CATALOG PRODUCT NOTIFICATION

Date:	May 14, 2018		
Customer Part Number:	1297-1274-ND	Würth Electronics Midcom Part Number:	750811617
Customer Name:	Digi-Key	Würth Electronics Midcom Inside Sales Rep:	Theresa Tesch
Customer Contact:	Laura Perez

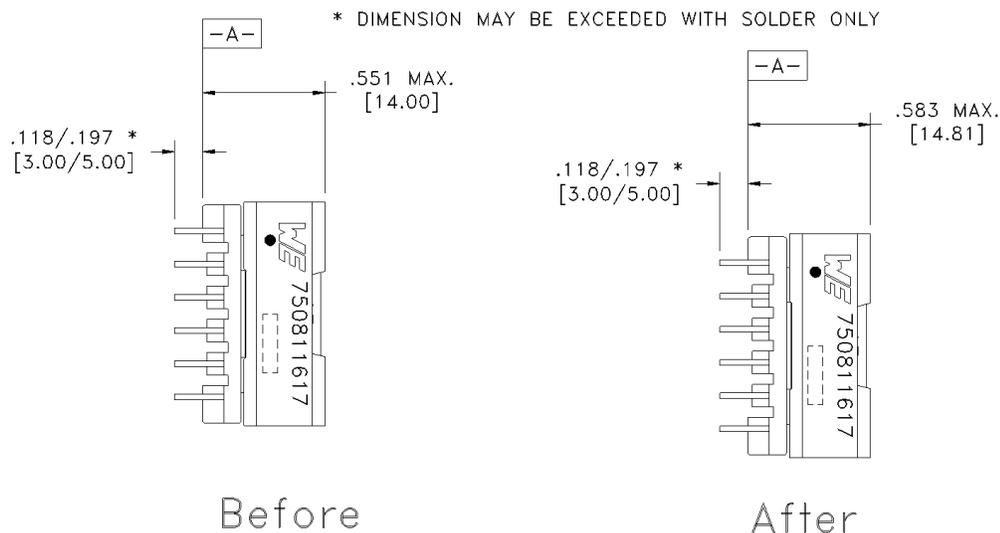
This product will have its maximum allowable height changed from 14.00mm to 14.81mm. The change is needed due to the heavy wire used in the part will sometimes lay on top of itself. This causes the coil to have a larger than typical height to it. Please see below for more clarification on the change.

There is no changes to this part electrically. The only change is to the allowable height of the part.
